# Work Order ID 85830

Item Name: Crosstube Turning Detail

DRAWING NO. D212-664-141	TITLE XTUBE ASSY (205/212/412 HI FWD)	REV. D	DART AEROSPACE LTD ENGINEERING ORDER		D.E.O. NO. D212-664-141-D-1	SHEET NO. SHEET 1 OF 2	SCALE NTS
DRAWN	CHECKED	MFG. APPR.	APPROVED	DE APPR.			
DATE 11.04.07	DATE 11.07.11	DATE 11.04.12	DATE 11/04/12	DATE 11.04.12

ADD AN INSPECTION WINDOW TO UNDERSIDE OF CROSSTUBE.

**D212-664-141/-141B  
ASSEMBLY DETAIL**

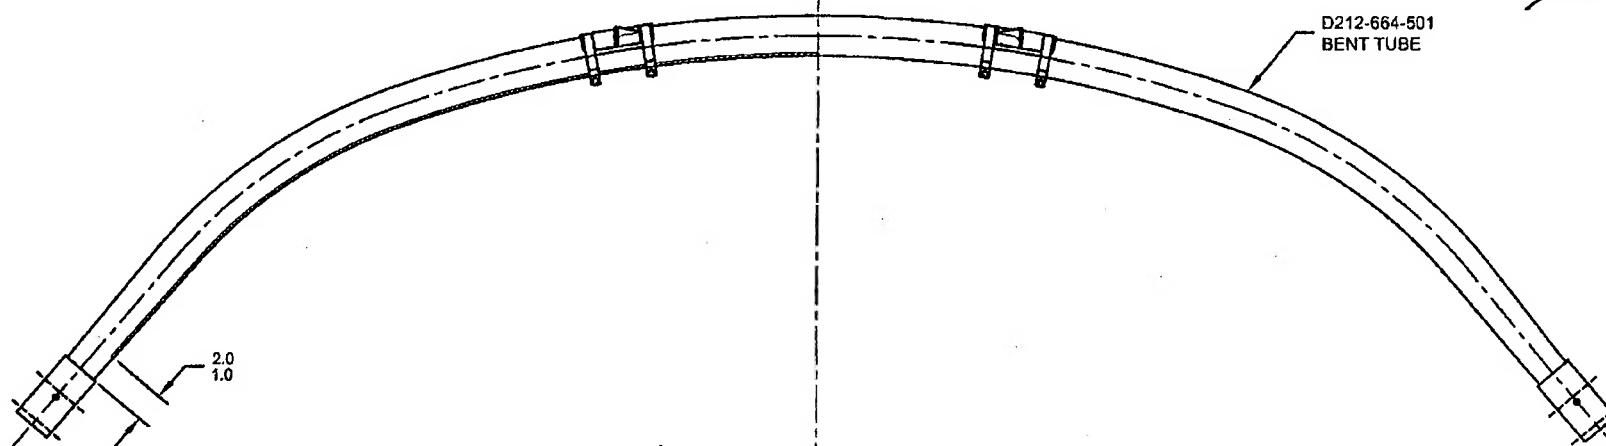
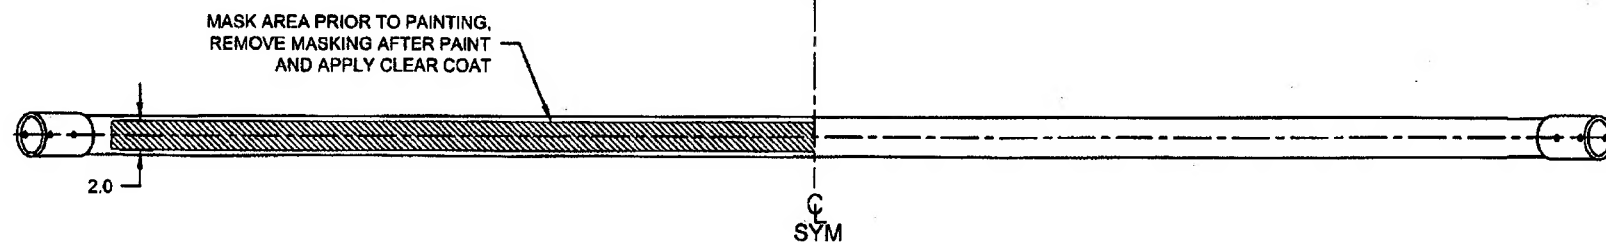
NOTES 2 OF SHEET 1 IS AMENDED AS FOLLOWS:

- 2) FINISH: CHEMICAL CONVERSION COAT PER DART QSI 005 4.1  
PRIME INSIDE AND OUTSIDE PER DART QSI 005 4.2  
MASK UNDERSIDE OF CROSSTUBE AS SHOWN (HATCHED AREA) AND  
PAINT OUTSIDE PER DART QSI 005 4.2  
REMOVE MASKING AND APPLY CLEAR COAT

- 2) FINISH: CHEMICAL CONVERSION COAT PER DART QSI 005 4.1  
PRIME INSIDE AND OUTSIDE PER DART QSI 005 4.2  
PAINT OUTSIDE PER DART QSI 005 4.2
